# Stormwater Division

Project Name: Ford's Colony Section XII  
Structure/BMP Name: Dry Pond No. 1  
Project Location: Off Country Club Drive, Ford's Colony  
BMP Location: Northeast of Kilton Forest cul-de-sac  
County Plan No.: S - 51 - 02

**James City County Environmental Division  
Stormwater Management/BMP Record Drawing &  
Construction Certification Review  
Tracking Form**

Project Name: FORD'S COLONY SEC 12  
 County Plan No.: S-51-02  
 Stormwater Management Facility: TIMBER WALL DRY POND #1  
 BMP Phase #:  I  II  III  
 Information Package Received. Date/By: 05/15/06 AES  
 Completeness Check:  
 Record Drawing Date/By: 5/16/06 / 11/19/07  
 Construction Certification Date/By: 11/19/07 AES Jason Grimes, P.E.  
 RD/CC Standard Forms (Required for all BMPs after Feb 1<sup>st</sup> 2001 Only)  
 Insp/Maint Agreement # / Date: Comm #4 JUNE 21 2002, 030002434  
 BMP Maintenance Plan Location: page 23 JAN 27 2003  
 Other:  
 Standard E&S Note on Approved Plan Requiring RD/CC or County comment in plan review  
 Yes  No Location: page 21 note #20  
 Assign County BMP ID Code #: Code: PC 207  
 Preliminary Input/Log into Division's "As-Built Tracking Log"  
 Add Location to G

**PLAN VIEW**  
**DRY POND #1 PRESSURE TREATED WOOD DRY DETENTION STRUCTURE**  
SCALE: N.T.S.

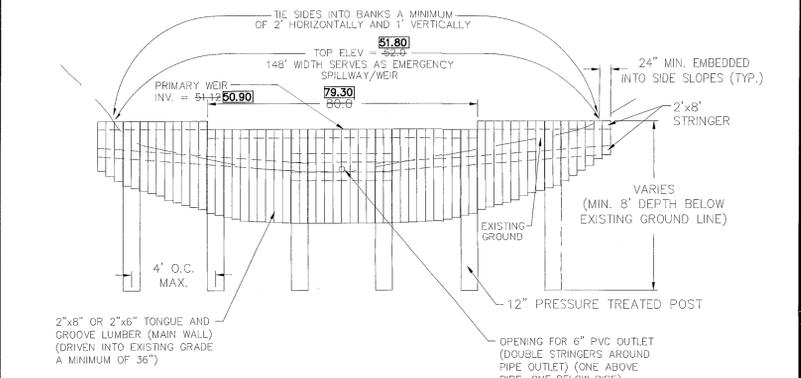
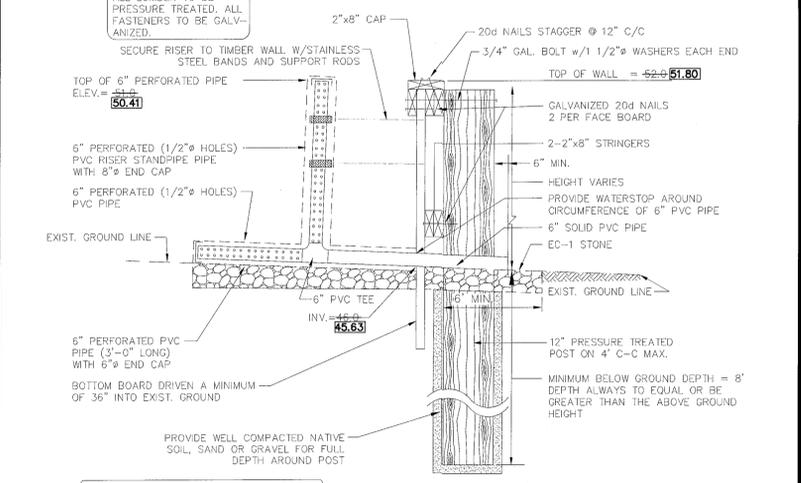
43. BMP Designs. Show the 10-year design storm event hydraulic routings for BMP's # 1 and # 2. The 10-year water surface elevations for the BMPs should be contained within the 1 ft. deep "principal spillway" weirs for both facilities and not crest over the tops of the walls (designated as emergency spillways on Sheet 23).

44. BMP # 1 Design. The tailwater elevation assumption used for design of BMP # 1 is at an elevation well below existing ground at the base of wall based on topography on Sheet 11. Assumptions for base tailwater should accurately depict depth of flow in the existing receiving channel.

46. BMP Construction. The sequence of construction on Sheet 21 does not indicate when the timber crib wall BMPs are to be constructed.
47. BMP # 1. Reroute the proposed sanitary sewer between Manholes # 12-A-11 and # 12-A-12 to avoid direct conflict with the timber crib wall structure for BMP # 1. The sewer cannot pass directly under the wall.

48. BMP Structural. Show maximum spacing of the 6-inch by 6-inch posts for the BMP walls on the details on Sheet 23. Ensure post spacing and embedment depth below ground for the 6-inch by 6-inch treated posts as shown on the same detail is sufficient for structural stability of the walls for both BMPs.

**Sedimentation Analysis**

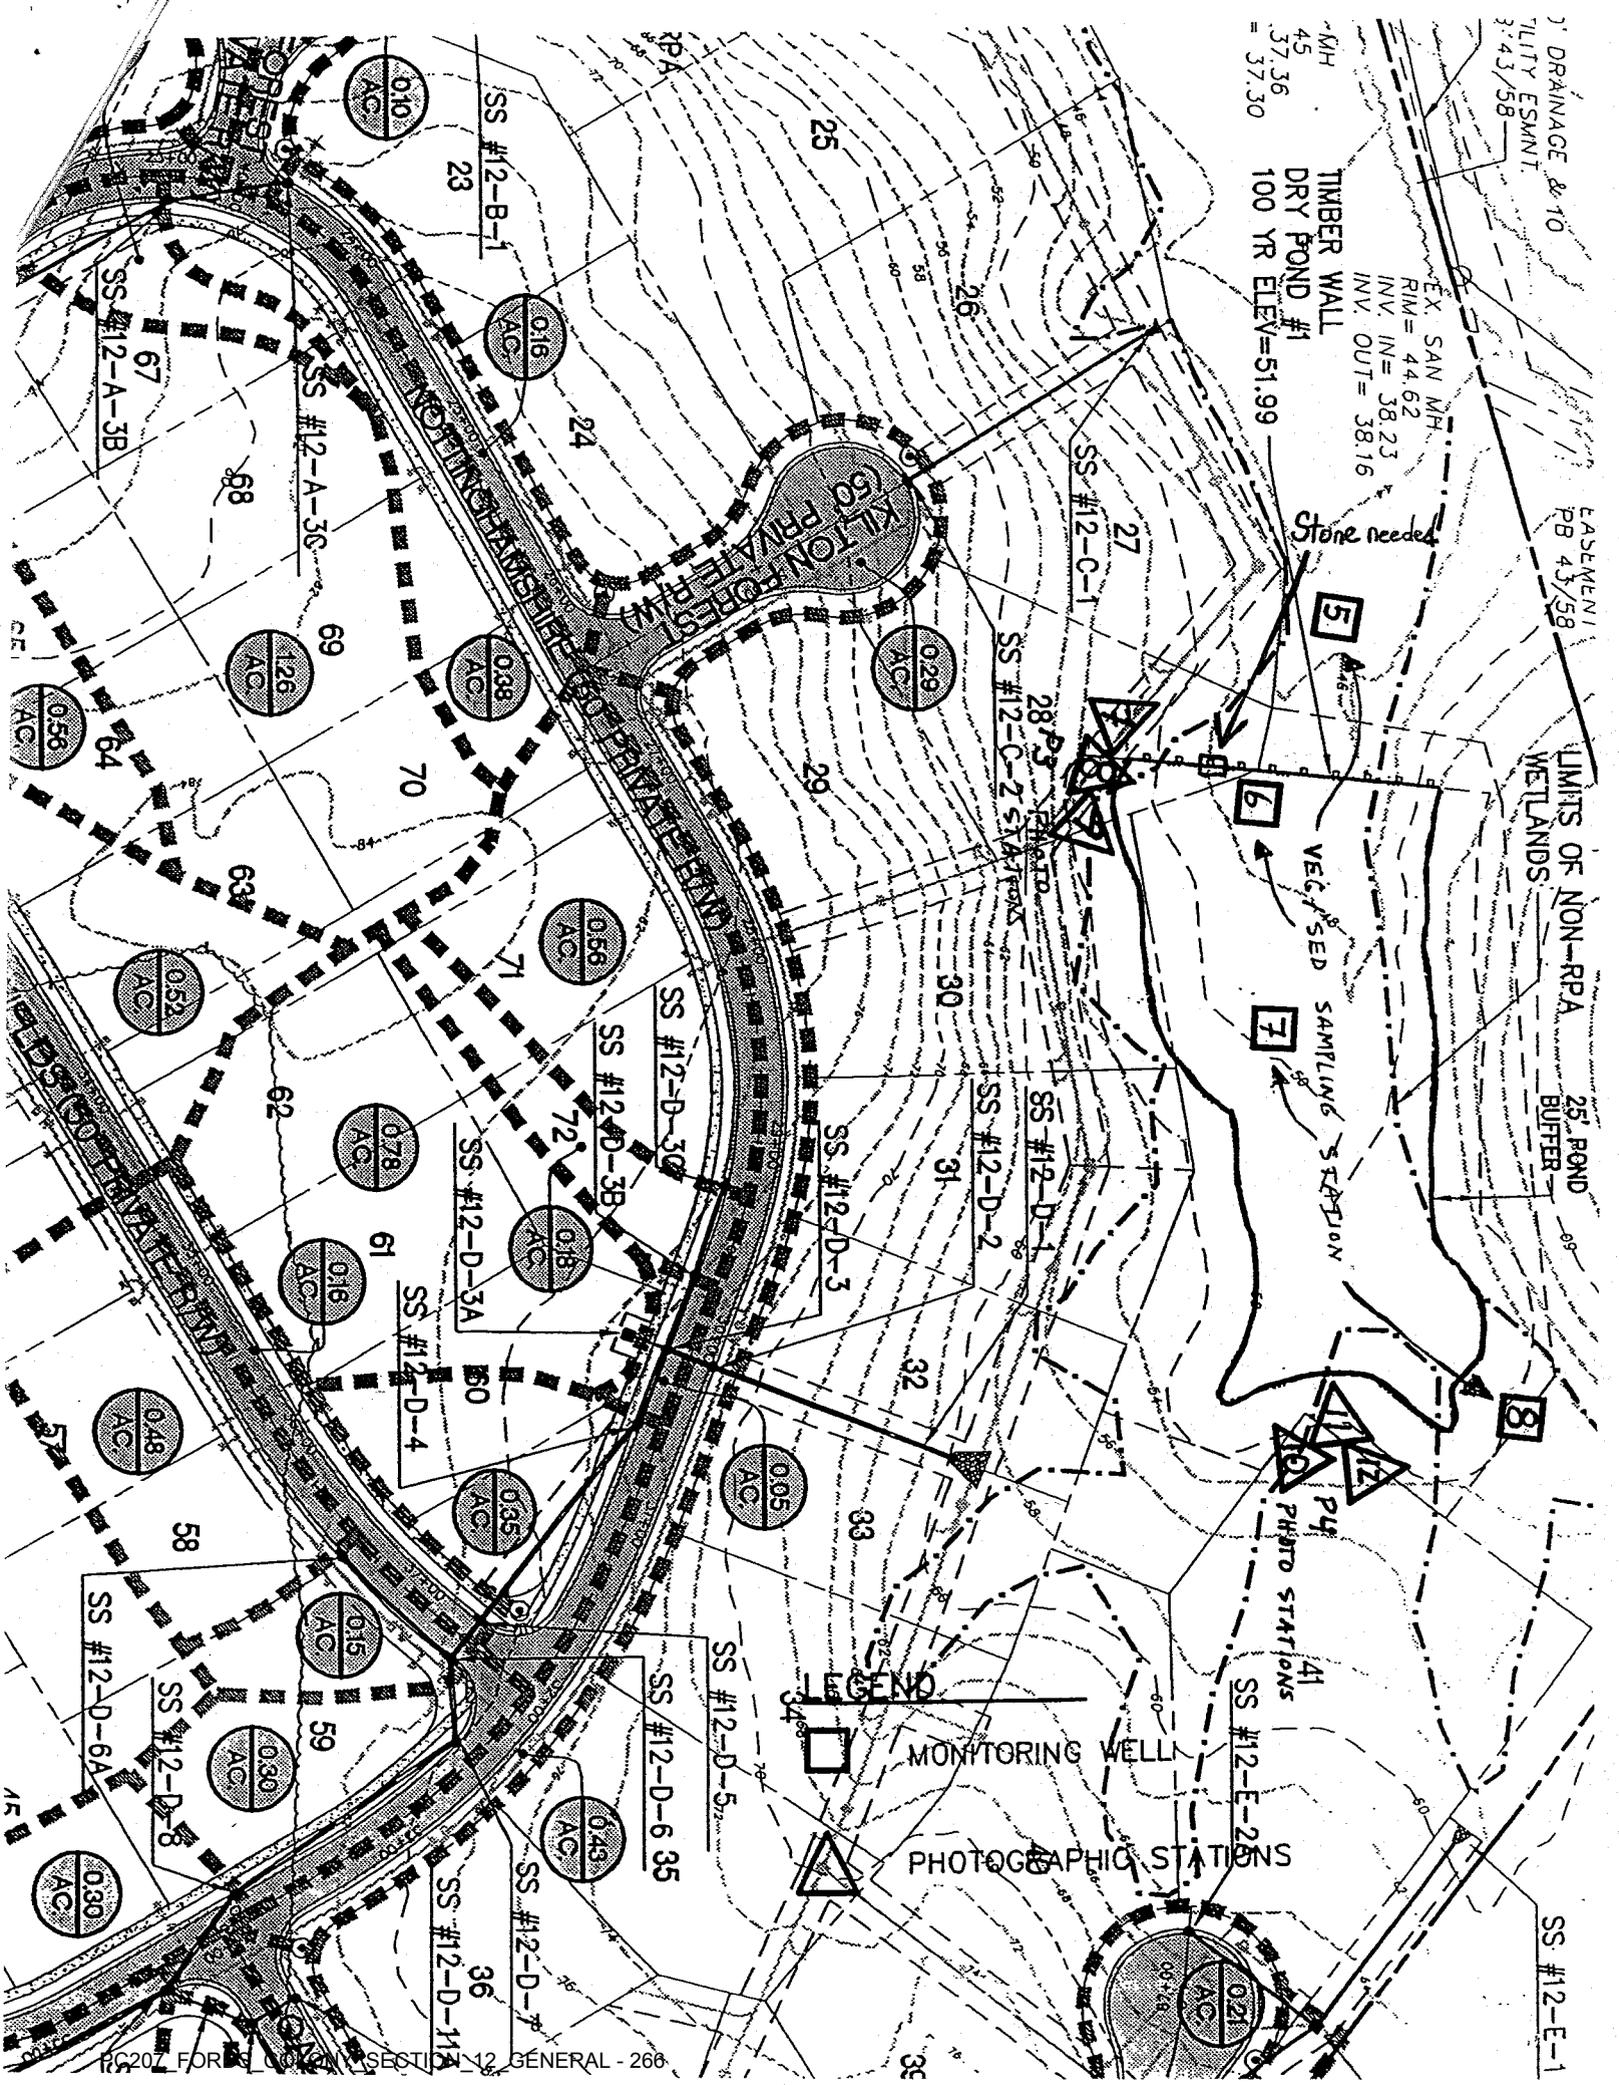
Displaced infiltration stone at cribwall #2 should be replaced in the 3 ft area shown on the attached photo #7.
